2011 Change Proposals - New Allowances (4 Items) Posted by joepaluch - 27 Oct 2010 06:04

These are **PROPOSED** Changes only based on driver and director suggestions. Please comment below. These are prposed NEW allowances to the 944 spec rule set.

2011-3) Allow 924S models to use 924 Carrera GT type flares on the rear.

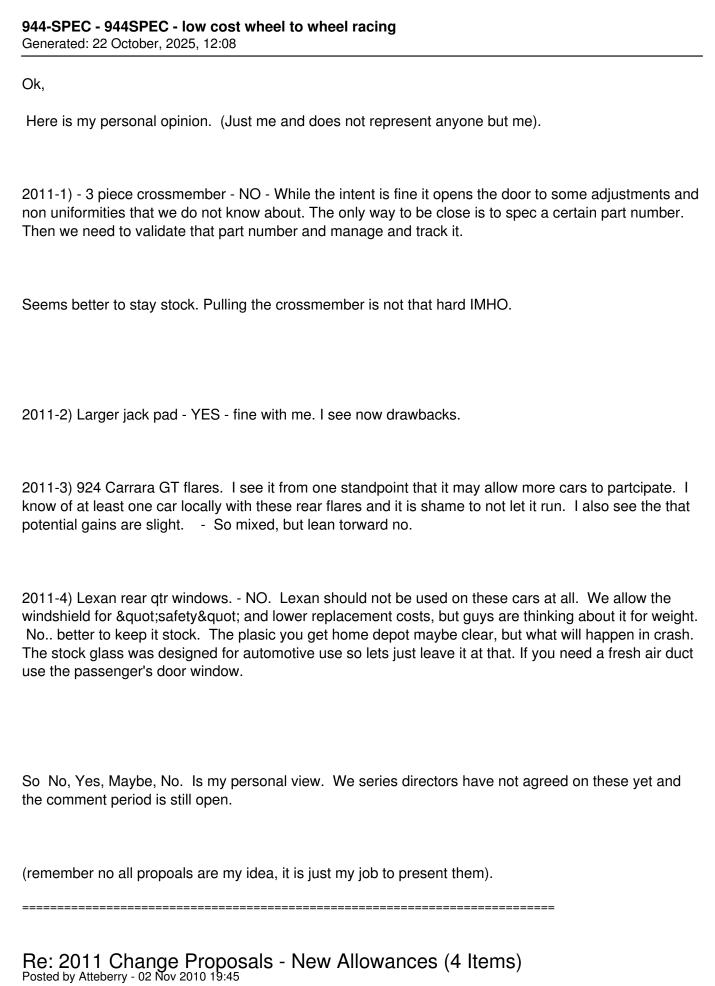
Proposal: All 87 and 924S chassis to install fiberglass 924 Carrera GT/ GTS type rear flares. Flares limited to units produce by GT racing part number xxxx (TBD). Track with may be increased the limit of the 944. If rear flares are installed the front must also convert to 944 steel fenders.

Justification: This allows a simple easy way for a narrow 924S to achieve the same track width as allowed by the 944. Front bodywork will be identical to the 944 and the rear flares are a cheaper solution than using 944 rear gtr panels.
